HORTON COASTAL ENGINEERING PTY LTD
18 Reynolds Cres
Beacon Hill NSW 2100
+61 (0)407 012 538
peter@hortoncoastal.com.au
www.hortoncoastal.com.au
ABN 31 612 198 731
ACN 612 198 731

29 March 2017

Horton Coastal Engineering Pty Ltd ats NSW Coastal Panel (Land and Environment Court No. 324345 of 2016), Response to 15 March 2017 Letter from Beatty Legal

Figure 1: Unspecified dimensions (in red) from end effects shape in Carley et al (2013)

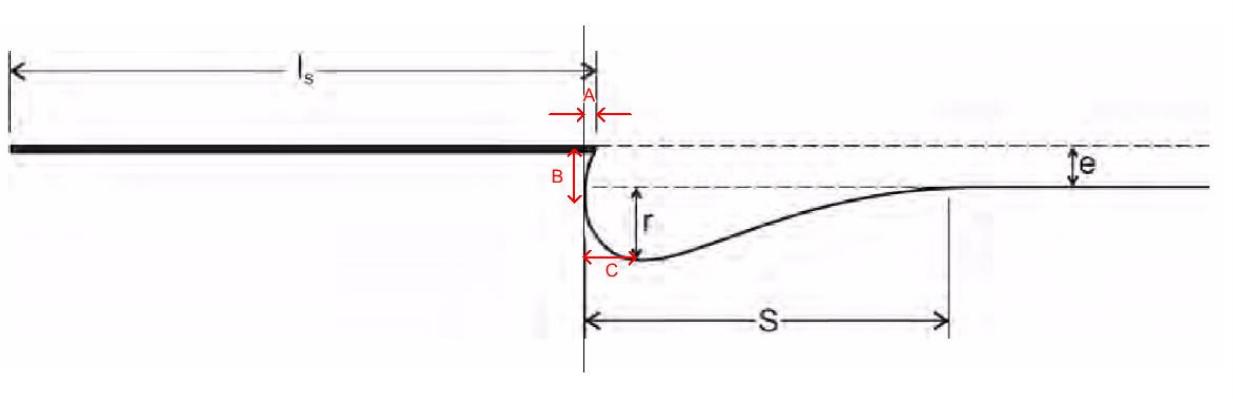
- (a) while the maximum additional erosion (AE) and alongshore extents (Ls) of the end effects appear to be plausible, the shape of the end effect "embayments" shown in Figures 13 and 14 do not appear to match the shape shown in McDougal et al (1987) or Carley et al (2013). Please review and/or confirm the anticipated shape of the end effect "embayments";

"Although Mr Horton seems to correctly estimate the northern limit of additional erosion (and its maximum extent), the yellow line used by him for the end effect north of 25c (Figure 13 of Mr Horton's letter dated 8 March 2017) appears "peaky". Please explain why Mr Horton's yellow line north of this "peak" (ie, the maximum erosion extent) does not appear to conform with the shape shown in McDougal and Carley".

It is important to note that the McDougal/Carley end effects shape is not adequately dimensioned to fully define it. As depicted in Figure 1, none of the dimensions A (alongshore cutback of end effect landward of the protection works), B (cross-shore distance to the cutback from the protection works, or C (alongshore distance to maximum erosion extent) are specified in Carley et al (2013).
